# TRAFFIC SIGNAL INVENTORY PROJECT

FINAL REPORT

Sponsored by the Iowa Department of Transportation  
CTRE Management Project 00-67

**Figure 12 Controller for Intersection 17**

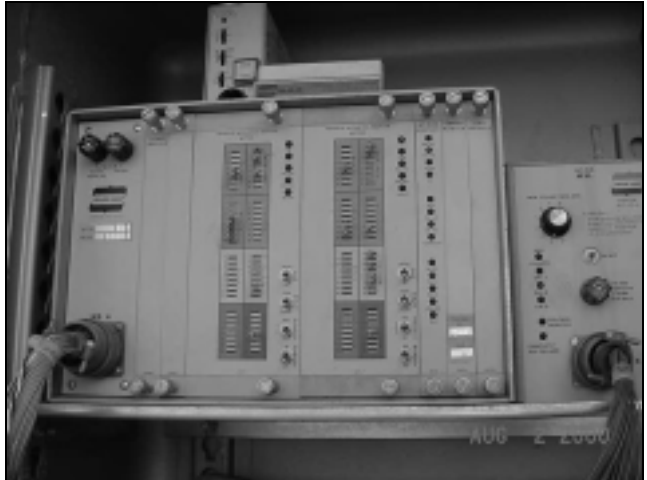
Operations: There was no timing sheet in the cabinet. The controller is very outdated (see Figure 12). Recommend upgrading to a more state of the art controller.

**Figure 15 Right-Turn Phasing at Intersection 29**

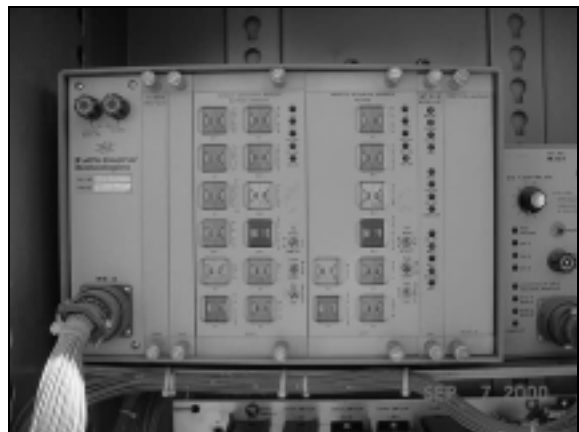
MUTCD: Backplates are not present on the mast-arm signals at McGregor. The remaining five signals have the appropriate backplates. The State/Phillips intersection had an unusual display for a right-turn protected phase that does not meet MUTCD requirements (Section 4D.07). The right-turn display is required to be one of the following: red arrow-yellow arrow-green arrow, red-yellow arrow-green arrow, or red-yellow-green-green arrow. The indication at this intersection is red-yellow-green (see Figure 15).
